Historic Areas of Istanbul (Turkey) No 356 Bis

Date of ICOMOS approval of this report

Map showing the revised boundaries of the property - Sultanahmet Urban Archaeological Component Area

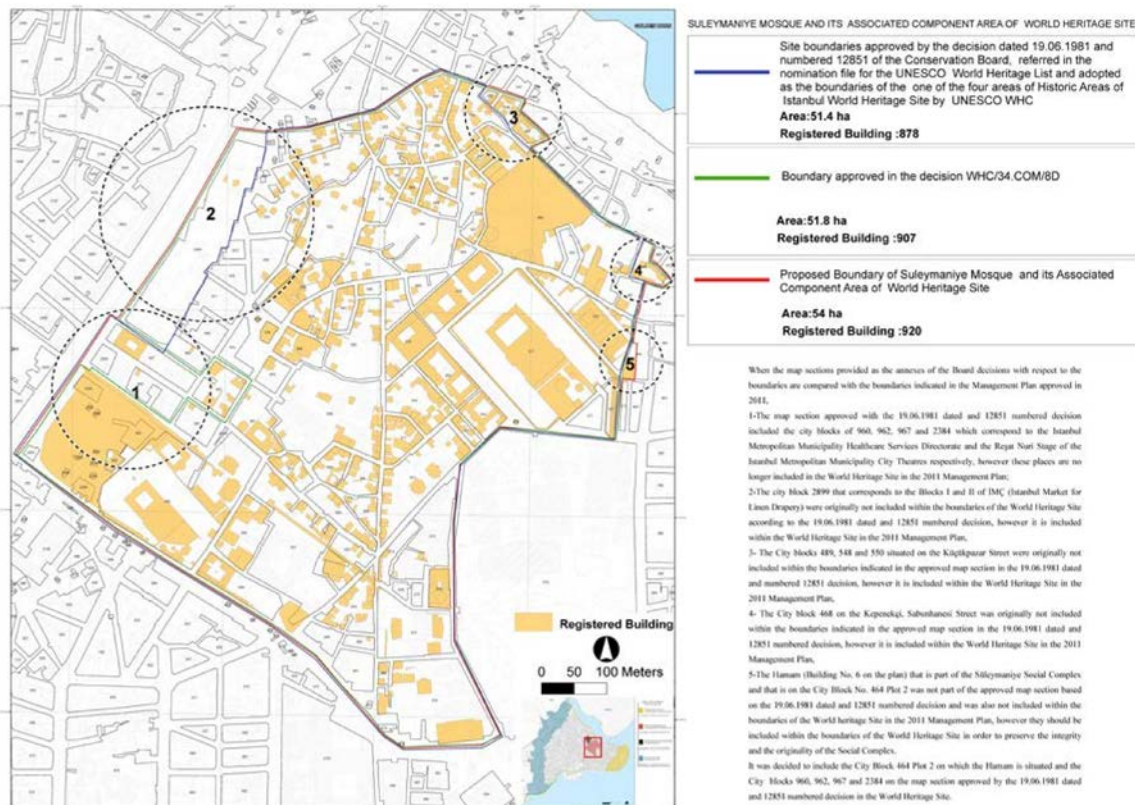
Sultanahmet Urban Archaeological Component Area of World Heritage Site (proposed area: 54 ha; 920 listed buildings)

The boundaries have been slightly extended to include the:

- Marmara Sea Walls;
- Historic grounds of the Topkapi Palace;
- Remains of the Boukoleon Palace.

Map showing the revised boundaries of the property - Süleymaniye Mosque and its Associated Component Area

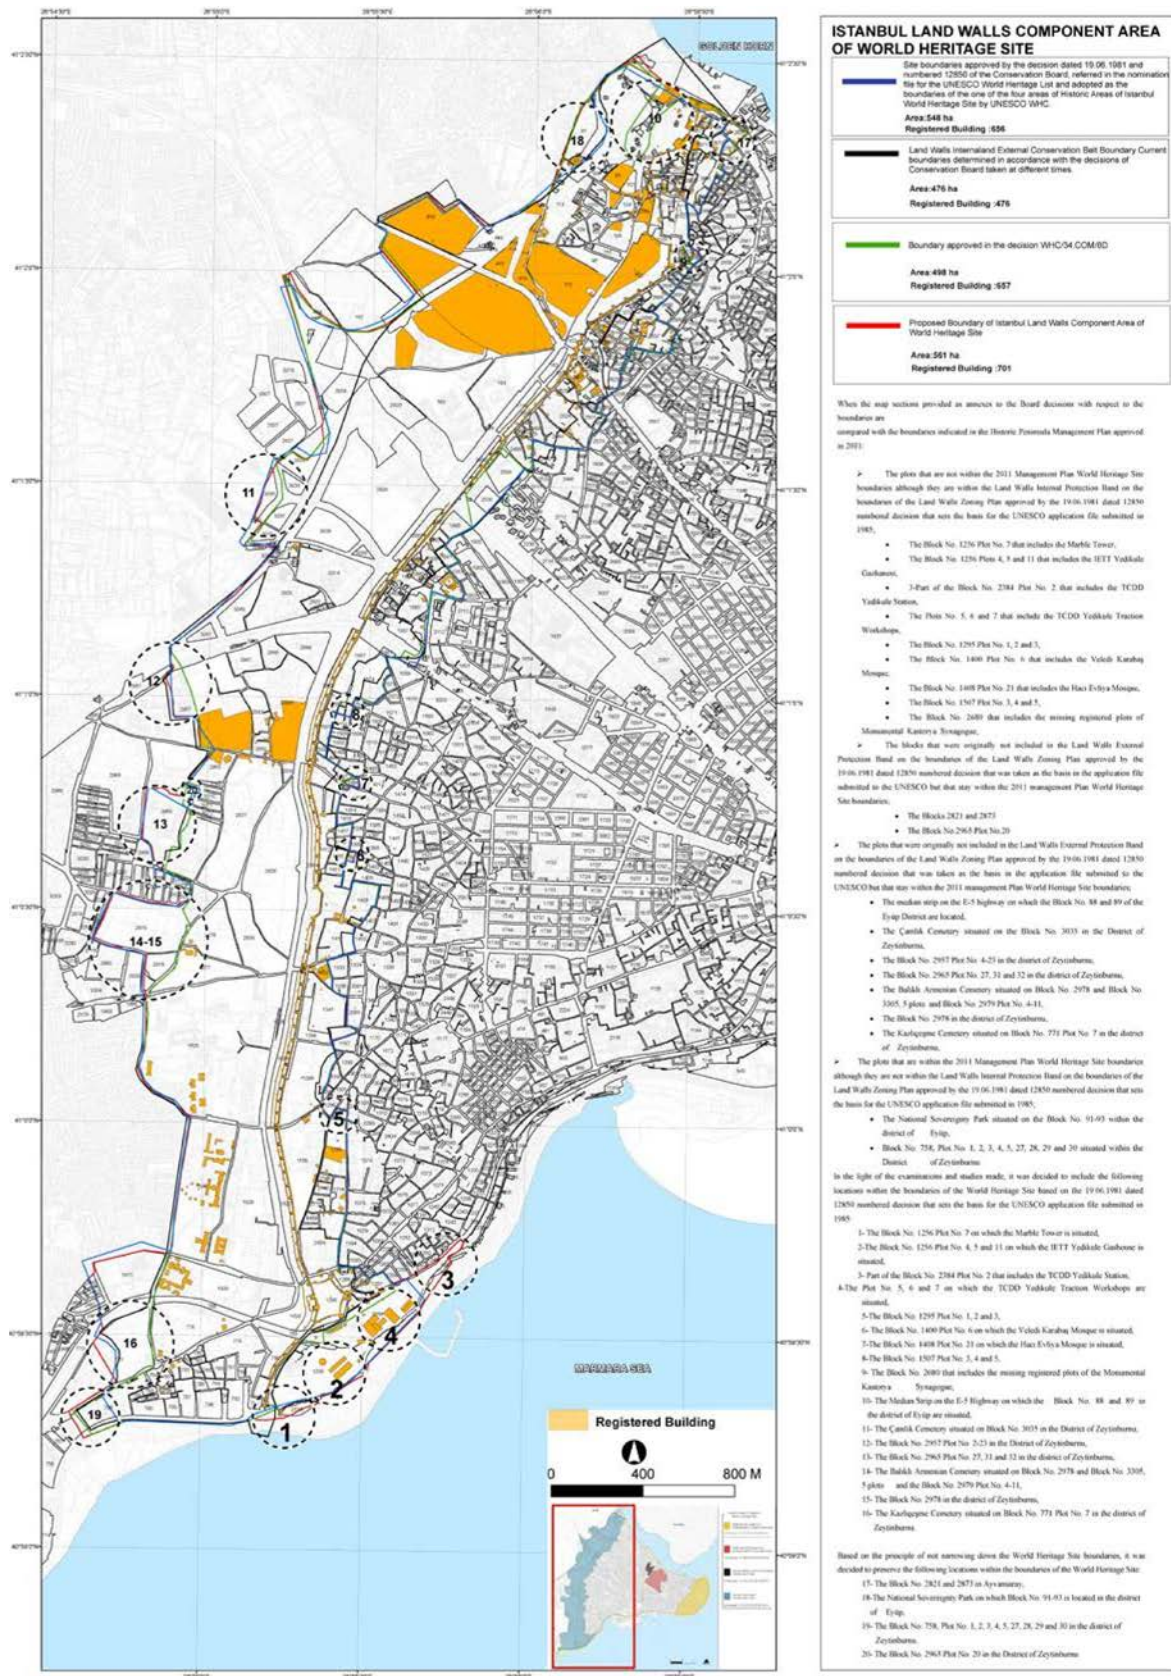
Süleymaniye Mosque and its Associated Component Area of World Heritage site (proposed area: 140 ha; 992 listed buildings)

The boundaries include the addition of:

- The Süleymaniye Hamam which is an integral part of the Süleymaniye social complex;
- City blocks 468, 489, 548, and 550 which are all part of the tight-knit grain of this part of the historic city;
- Blocks 2394 and 960 flanking the Valens Aqueduct;
- Blocks 960, 962, 967 and 2384 that close a gap.
